Summary and follow-ups from review of CE and TI requirements for FCC experimental sites

Michael Benedikt, CERN Friday 7 October 2022

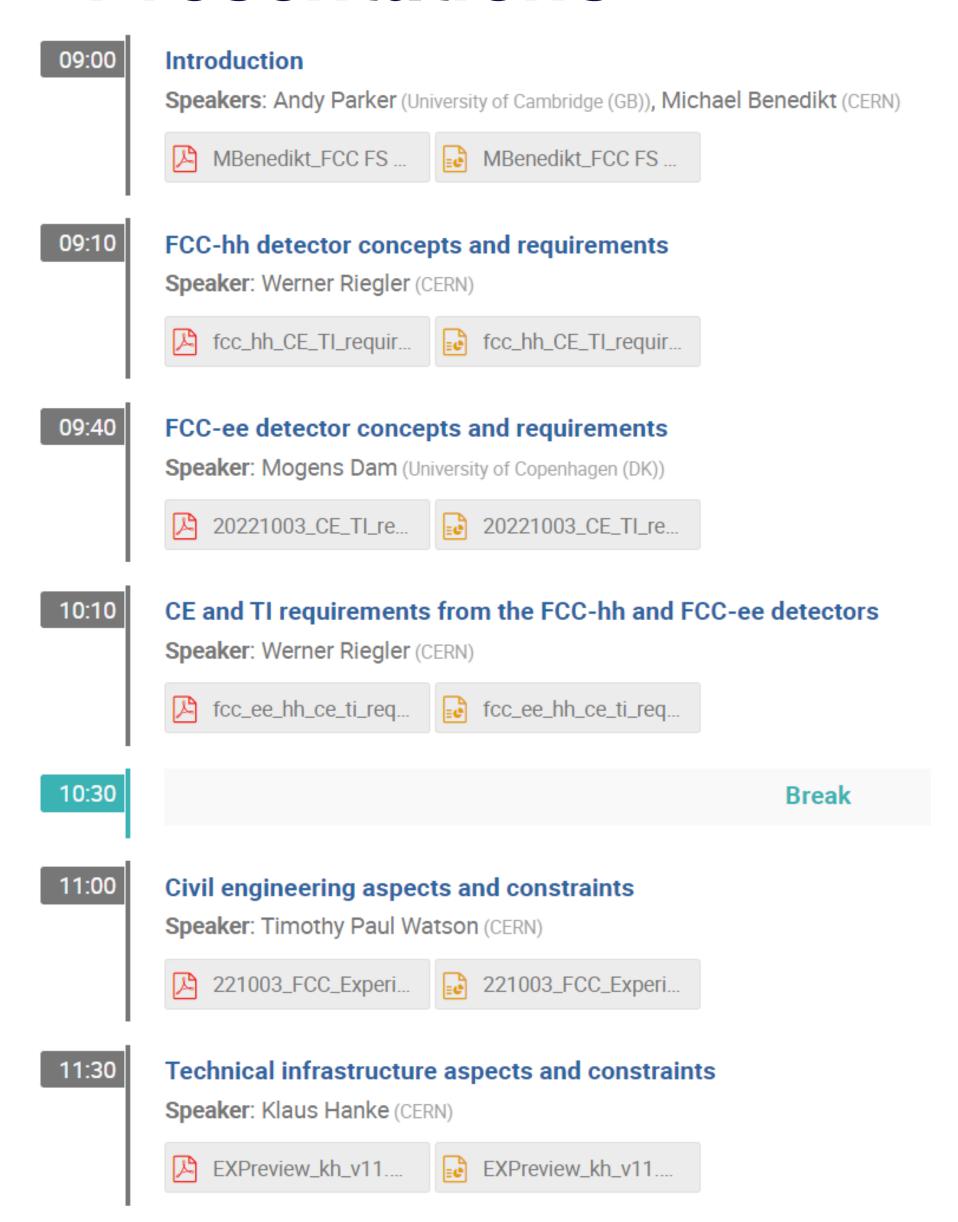
• The committee endorses the baseline concept for the FCC experiment site underground structures of an experimental cavern with a single experimental shaft for the main detector installation, linked via a transfer tunnel to the service cavern, with a second shaft, and connected via bypass tunnels to the machine tunnel on either side of the experimental area. This is an effective and efficient solution, taking into account also experience from LEP and LHC.

Shaft diameter: 17m

- The committee recommends that the cost change which would be produced by a change in the main cavern size be evaluated, in the event that it is possible to consider a smaller width than the default 35 m, perhaps as low as 30 m. Length: 66m
- The decision to operate the cavern with a single shaft has implications for the logistics of the detector installation and operation which need to be studied.
- Secondary experimental caverns could be of CMS size and costed for this.
- We recommend that the construction of the service caverns, even though not strictly required for FCC-ee, be not staged, subject to proper cost estimates being checked for initial and staged construction.

Also essential for FCC-ee, to keep machine cryogenic equipment vibrations far from the beam.
